# CITY OF ALBUQUERQUE

**RE: Broadstone Highlands Hotel Block- Springhill Suites  
Central and Mulberry NE  
Grading and Drainage Plan  
Engineer's Stamp Date: 6/18/18  
Hydrology File: K15D034B**

Re: Broadstone Highlands Hotel Block / Hydrology File K15D034B

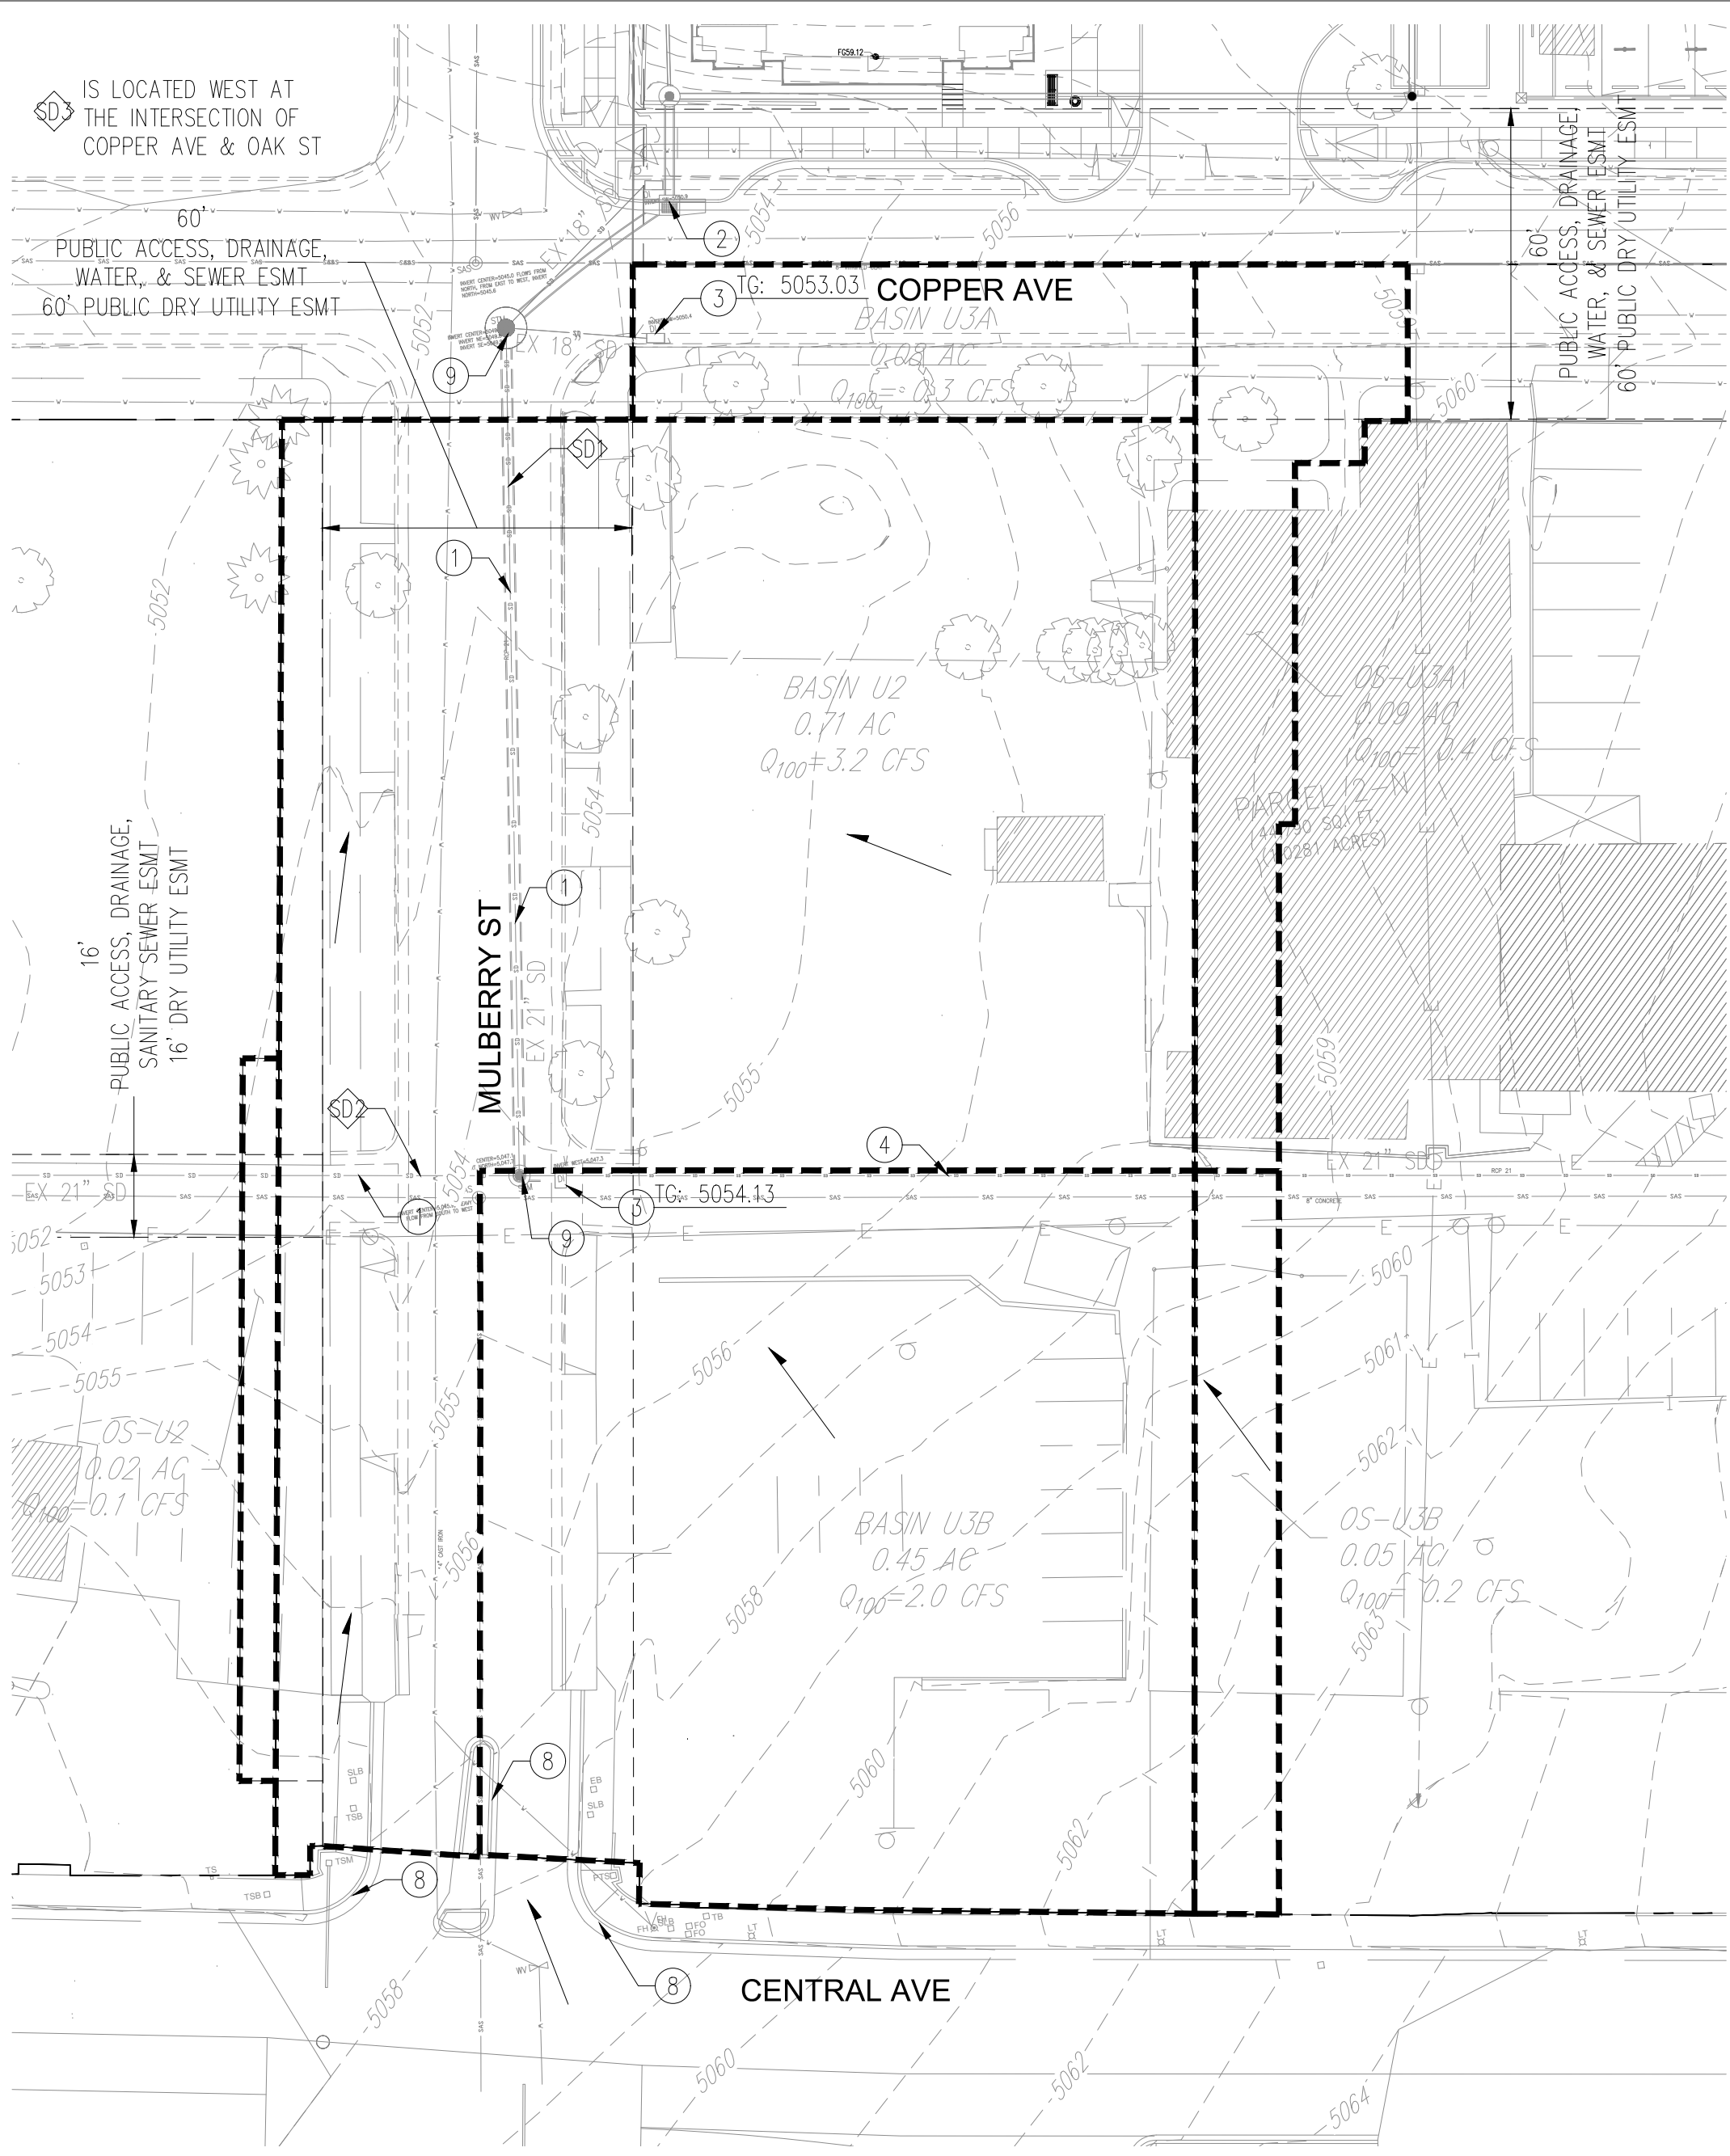
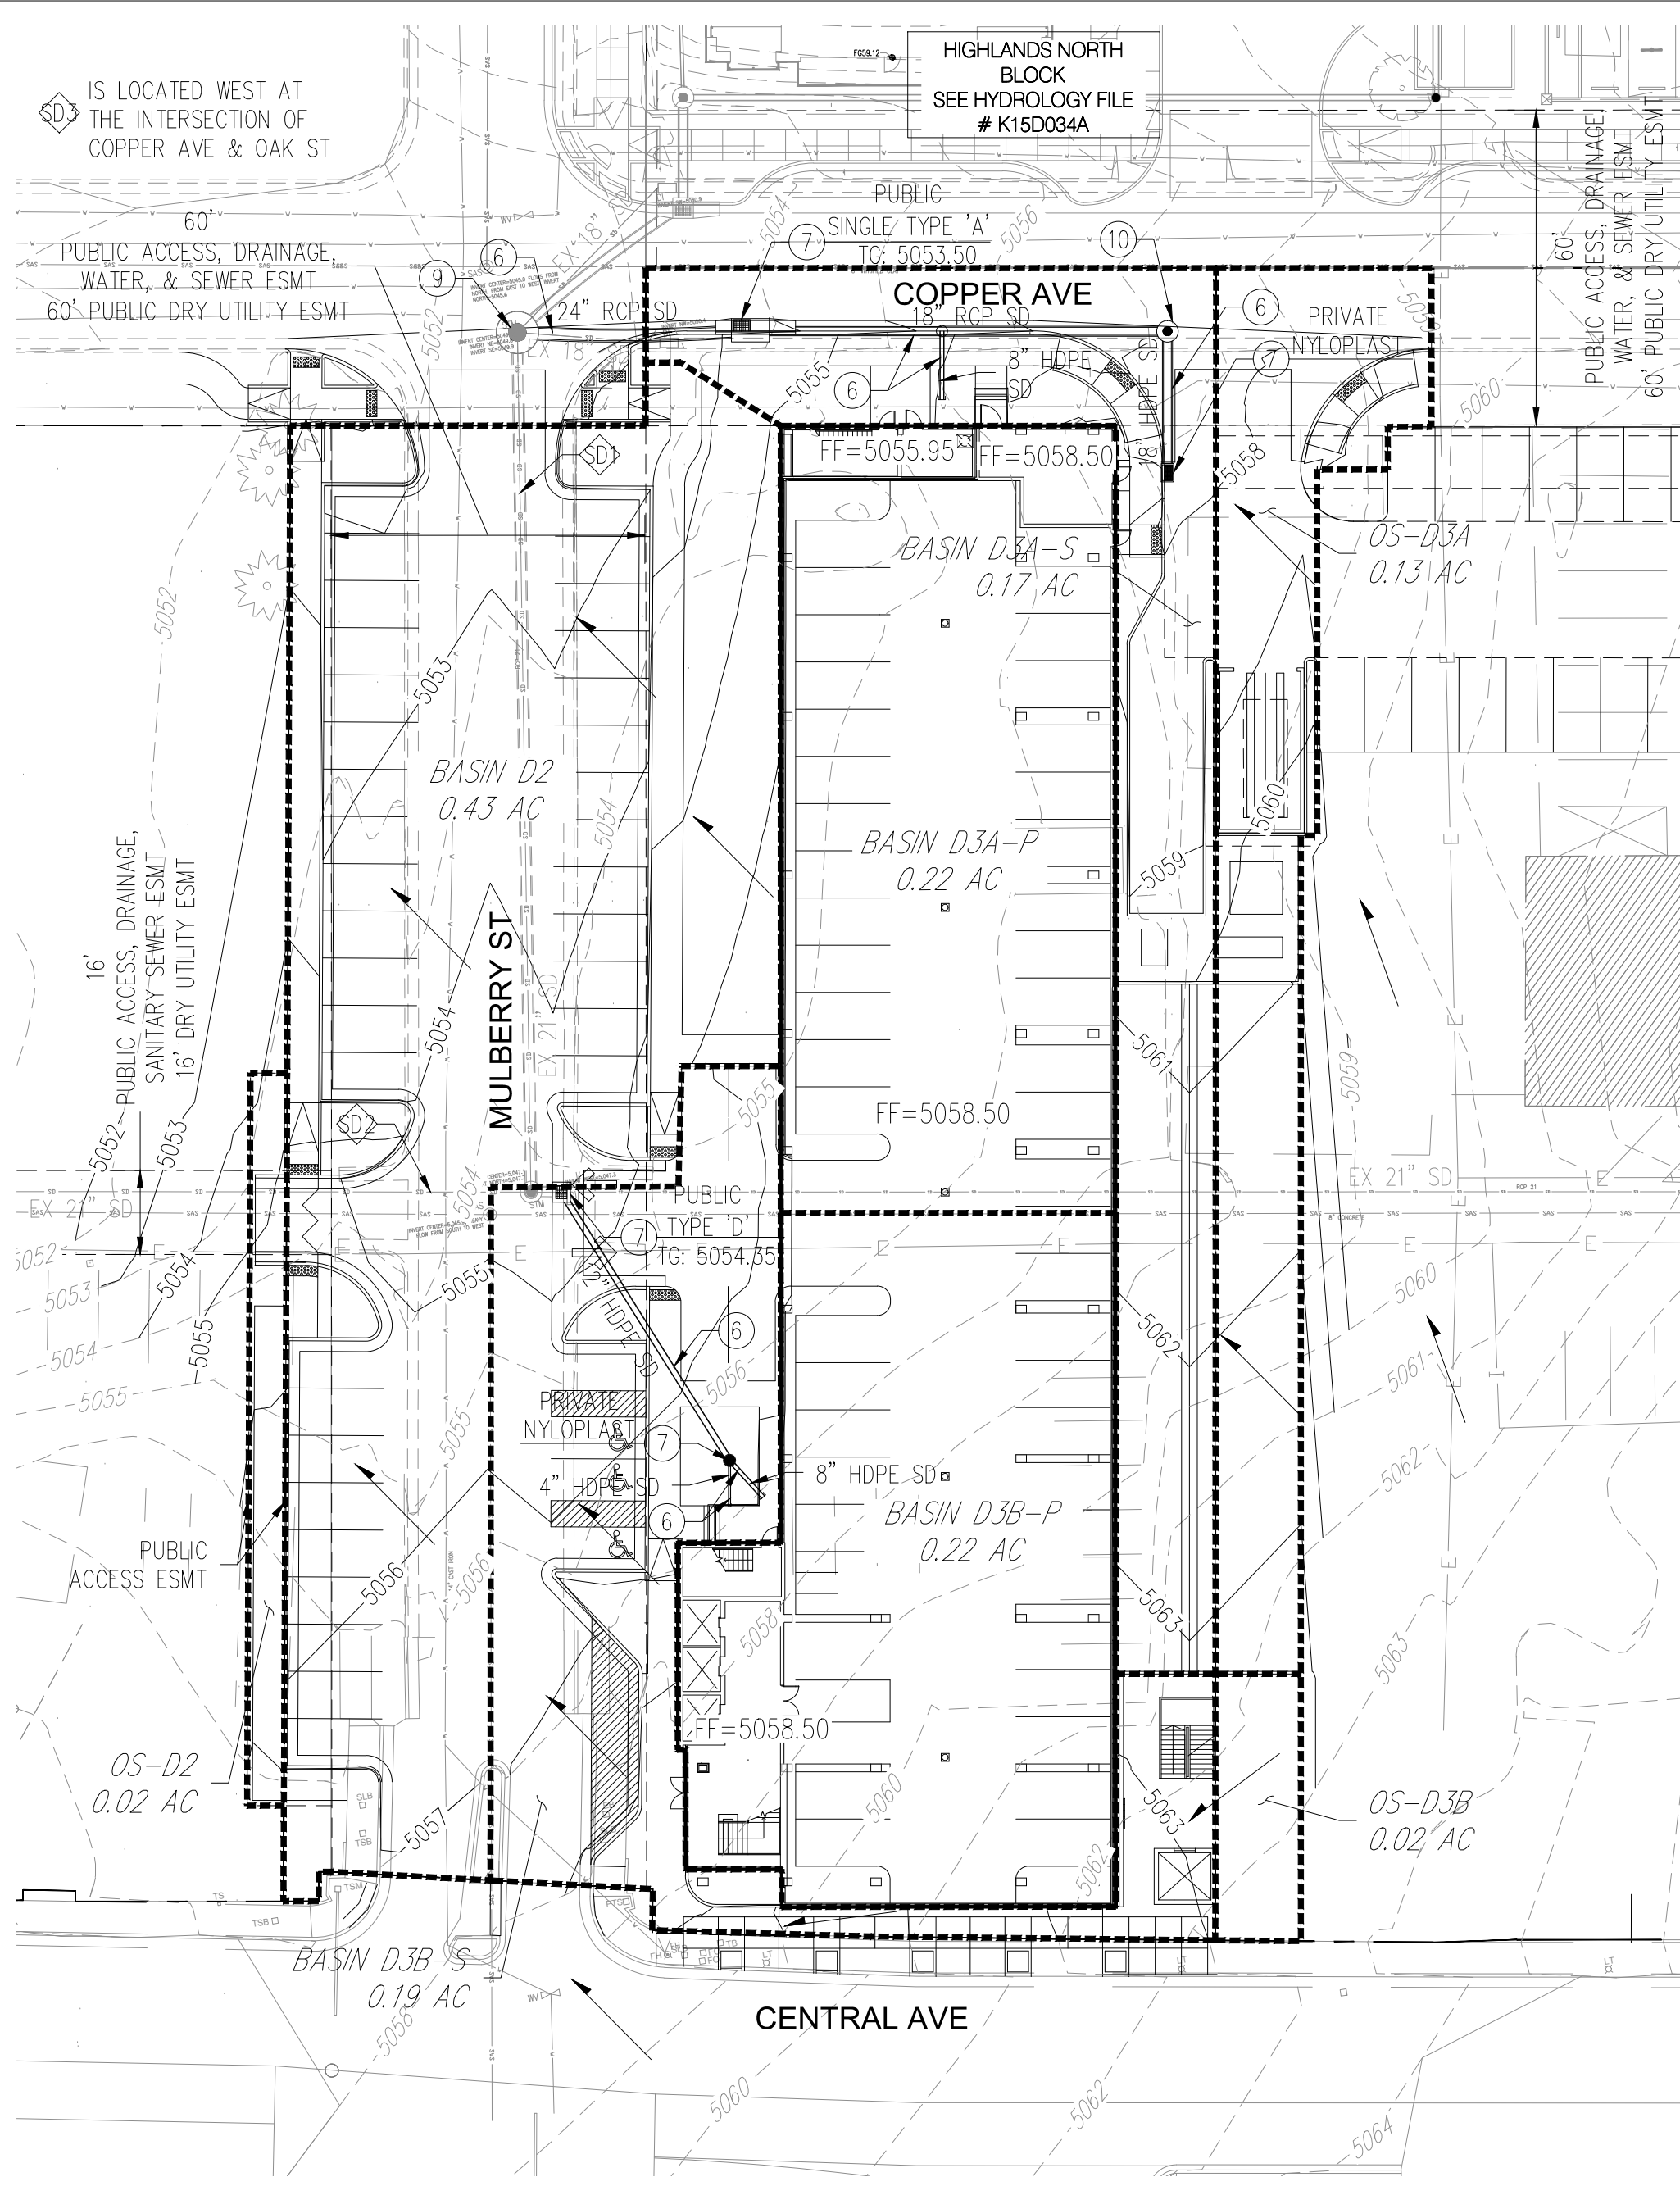
9. Please update the land treatments to reflect the subbasins so that the first flush requirement/fee-in-lieu amount can be determined. For instance it is unlikely that the rooftop drainage basins have 10% land treatment C. Payment of the fee in lieu for the required first flush volume will then be needed.

*Response: The land treatments have been updated to reflect the uses. It is noted that the fee in lieu will be paid based on a volume of 1,426 cubic feet.*

OVERALL GRADING &  
DRAINAGE PLAN

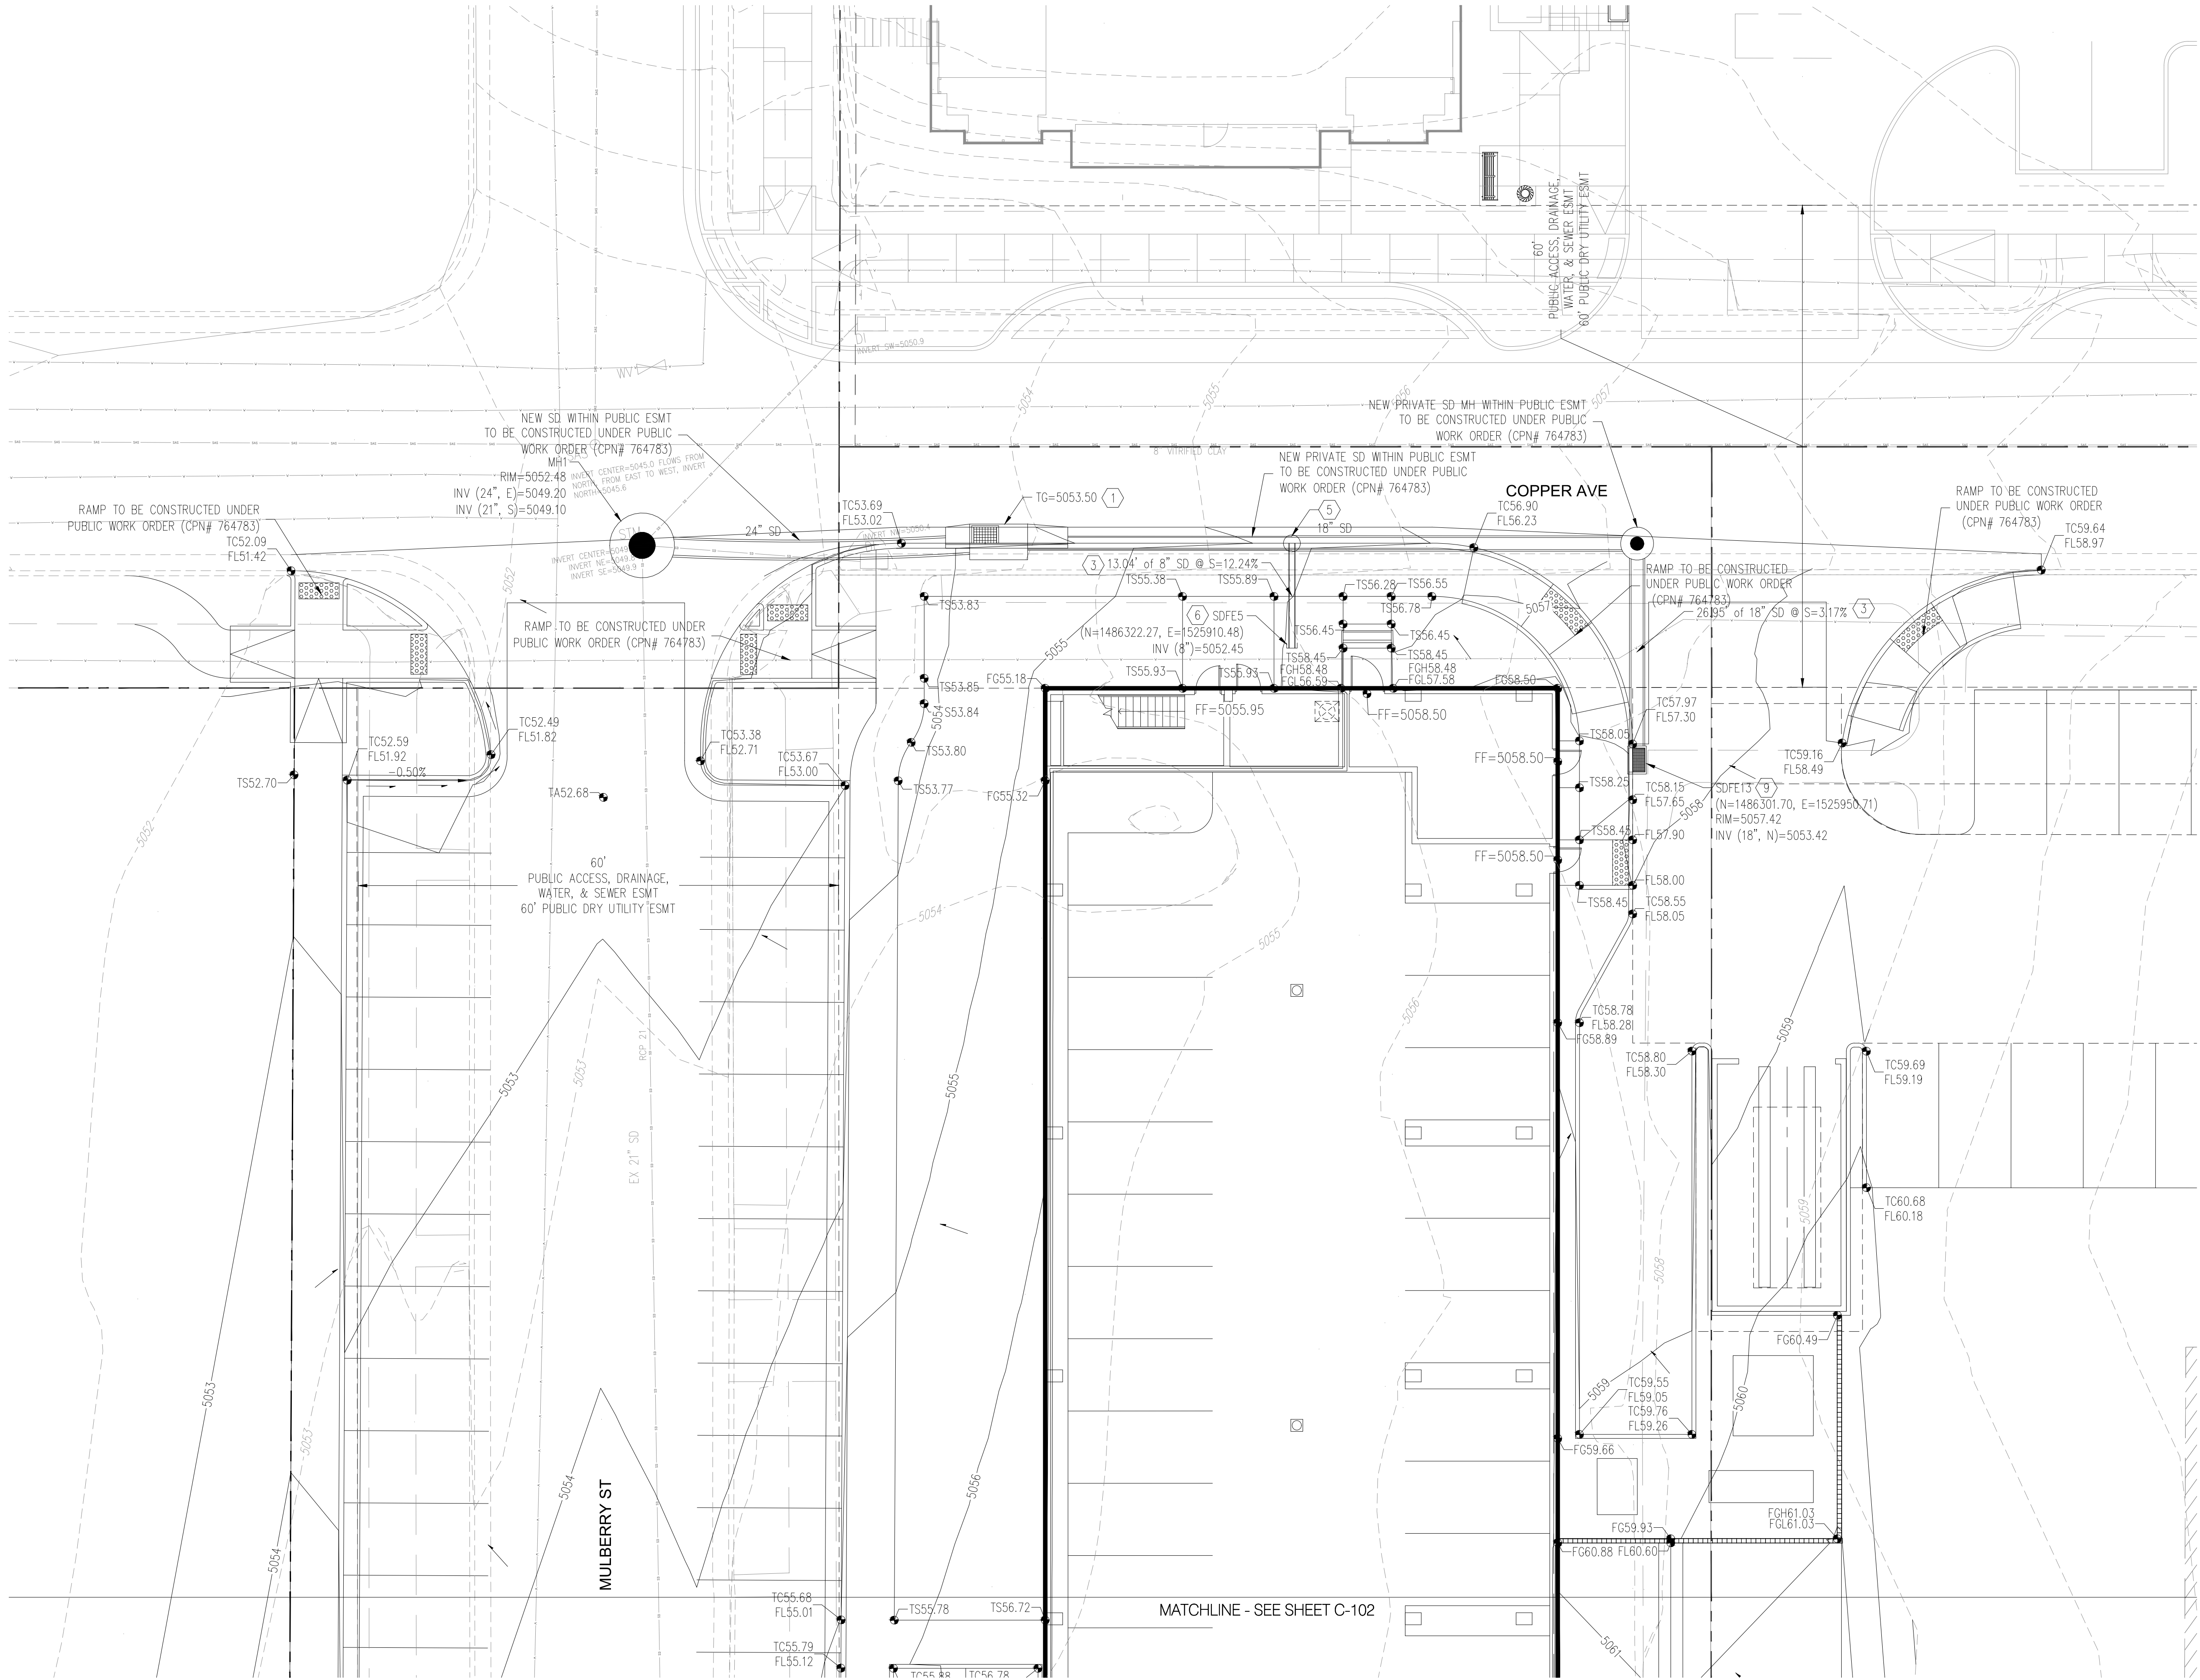
1. Clearly define which elements of the grading plan and drainage improvements are public and to be constructed by work order, and which elements are private and to be constructed by building permit.

2. Add note on the plan that "No work shall be performed in the public ROW and public easements without an approved Work Order".

*Response: The improvements located within the ROW/Public Easement have been better distinguished that they shall be constructed within a public work order set. Please see revised grading plans.*

*Response: This note has been added to the grading plan.*
